**Sydney Metro Chatswood to Sydenham
Environmental Impact Statement June 2016
Application Number SSI 15_7400**

Comment by:

Peter Egan
14/26 Hampden Rd
Artarmon 2064
04 1450 9700
Peteregan2001@hotmail.com

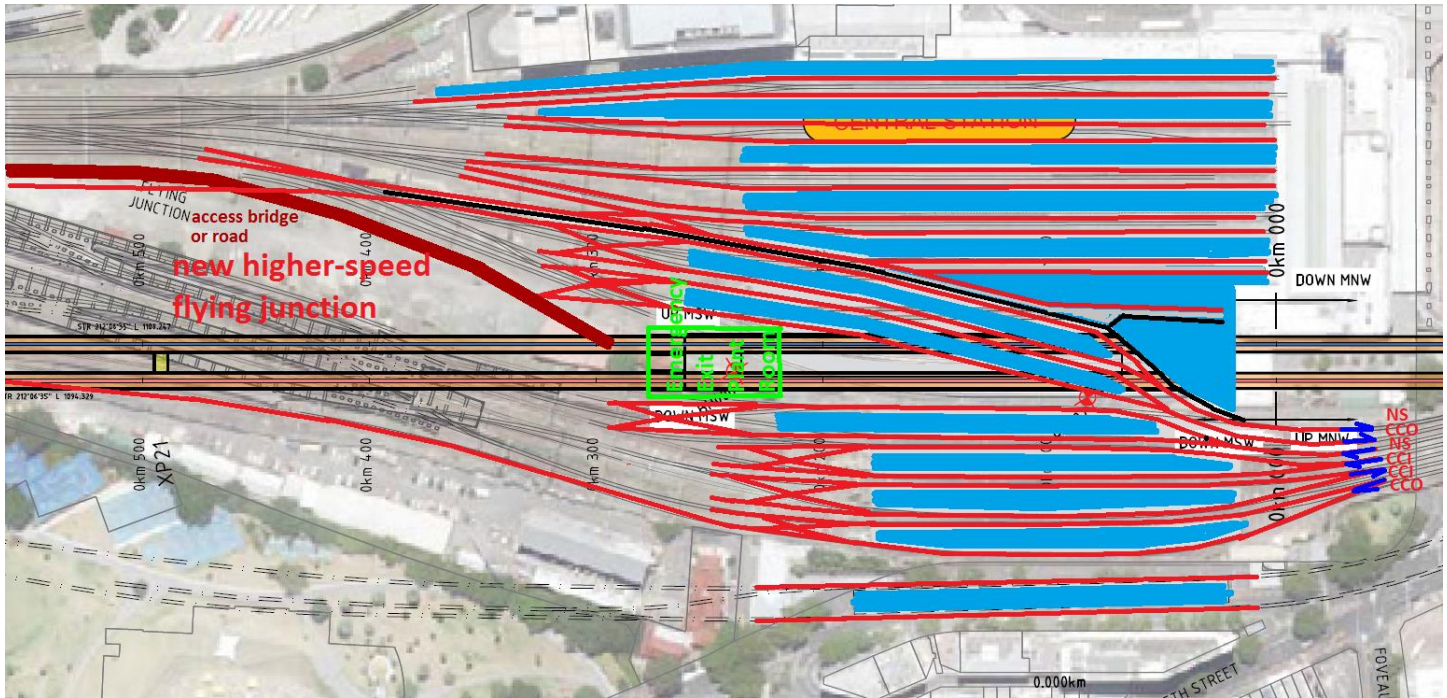
North Sydney station needs an entrance at its northern end to support future growth of the CBD

CENTRAL STATION CROSS SECTION

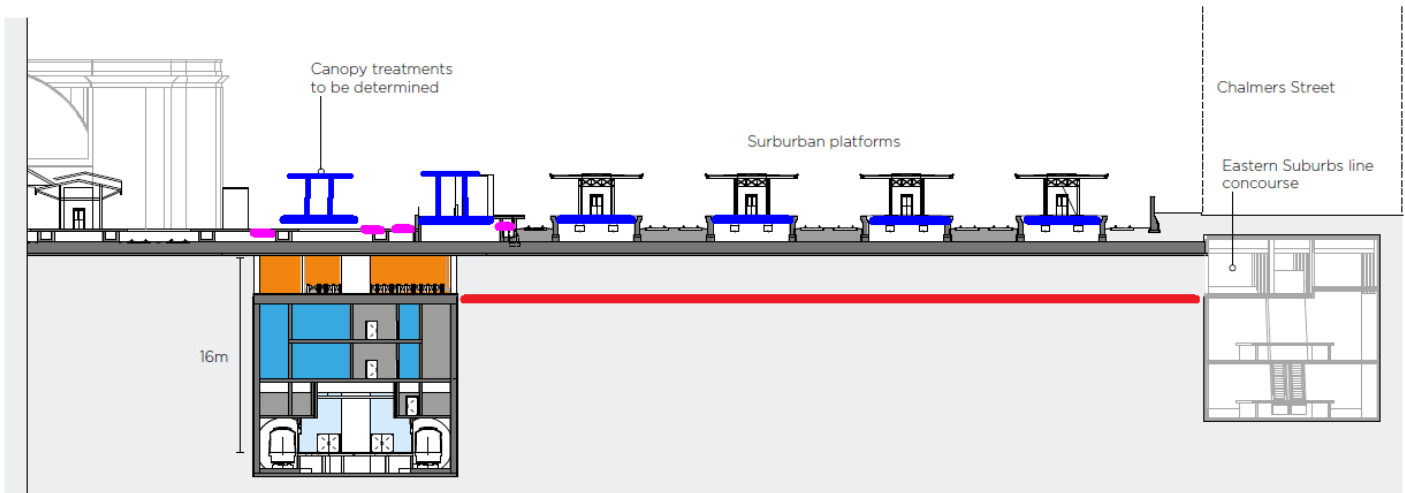
Central Station The roof of the Metro station is noted as “to be determined” in the EIS. The Metro plant room and emergency egress (green) is a significant intrusion into the Sydney railyard at surface level. Provision needs to be made for a rebuilding of the CBD Platforms to create a common concourse for Metro, Eastern Suburbs and aboveground platforms.

The CBD platforms and Flying Junction are 90 years old. They will be a century old by time of completion of this project. It’s time to plan for a new CBD Platforms station with 6 island platforms to serve the 6 lines in to the CBD, and to build a new flying junction to reduce the time for trains to pass through it. We need to plan for the existing network to have 30 driverless trains per hour each way capability.

A possible Pacific Hwy – Mowbray Road intersection upgrade arrangement

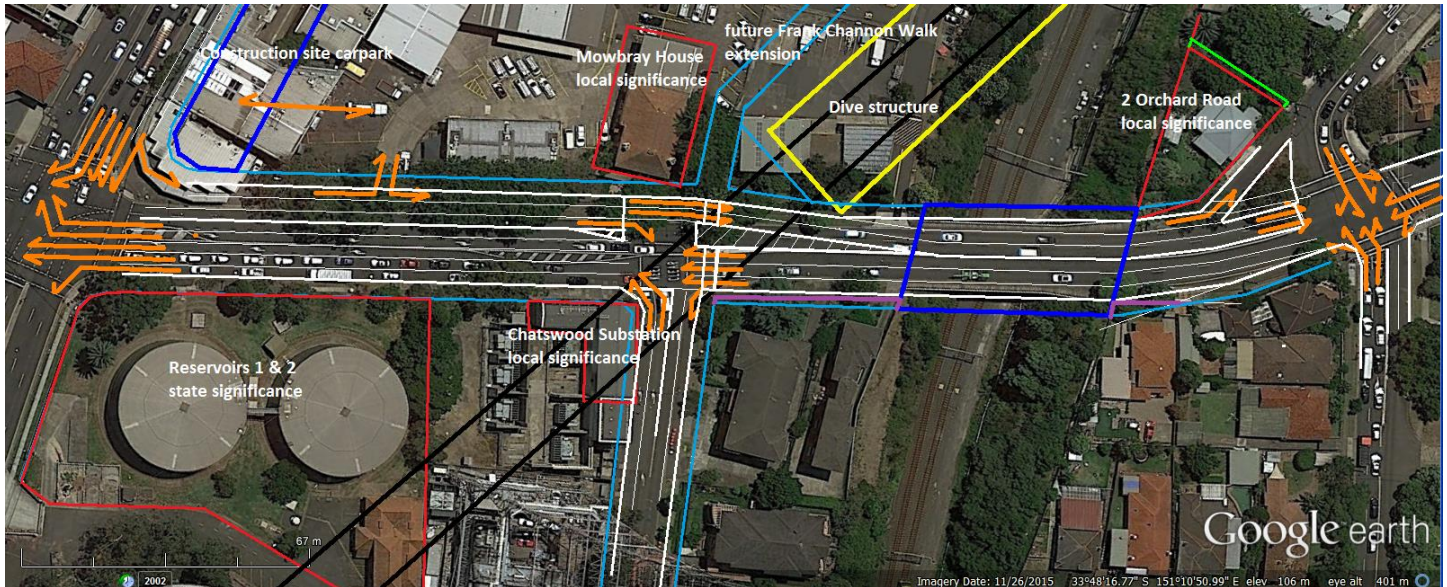
The Chatswood Metro construction site is in a very busy location. A 'to scale' layout of the site shows the demand for access points is at the western end. The heritage listed Mowbray House sits across the proposed site entrance at the Mowbray Road-Hampden Road intersection.

The APA requests a condition of approval to require analysis of the level of service improvement to be obtained at the Pacific Hwy-Mowbray Road intersection with it possessing: two dedicated right turn lanes for Pacific Hwy northbound and southbound;

Mowbray Road West with dedicated left and right turn lanes; Mowbray Road East with two dedicated right turn lanes and a dedicated left turn lane; and a 100 metre long right turn bay for Mowbray Road eastbound traffic to turn right into Hampden Road.

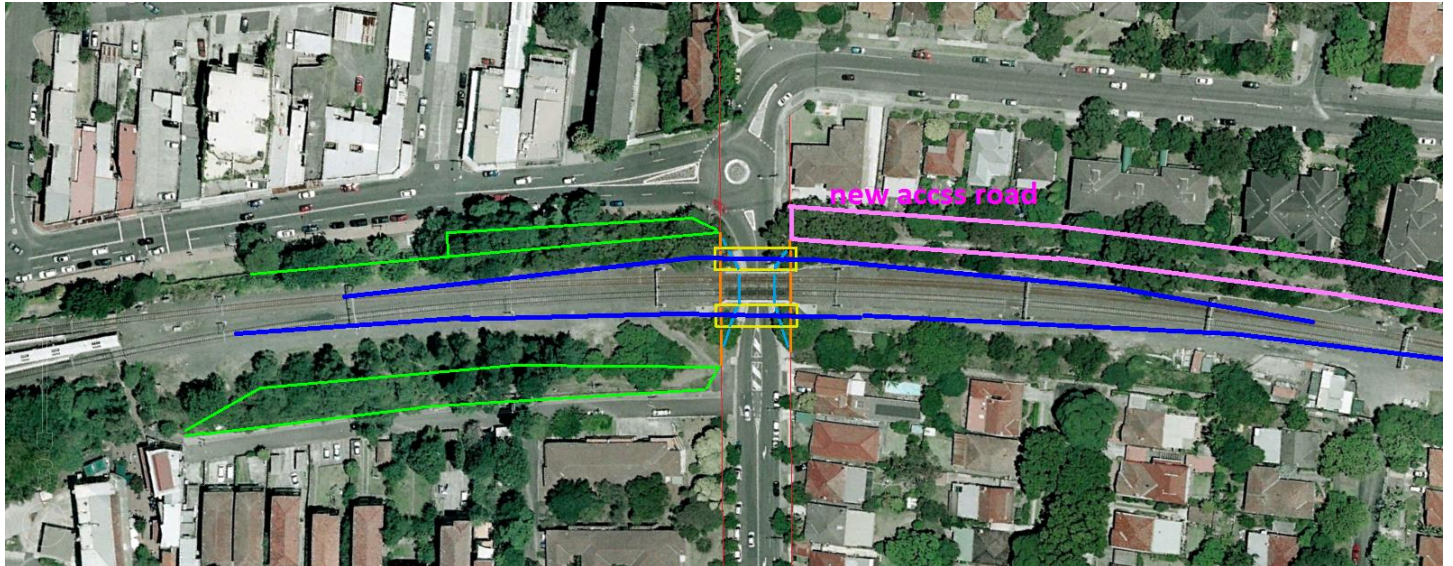
The EIS advises a new access road is being built on the western side of the North Shore line as shown in the above image. The new alignment and grade of the North Shore line reduces the speed of trains between Chatswood and Artarmon. The current steel rail bridge generates very loud train noise. The abutments of the original rail bridge intrude into Brand St and reduce visibility of the new corridor entry for passing traffic.

The corridor works should include a new low-noise (concrete) rail bridge spanning the full width of Brand St, improved track alignment and open space (green). Two better corridor/bridge layouts are given below.
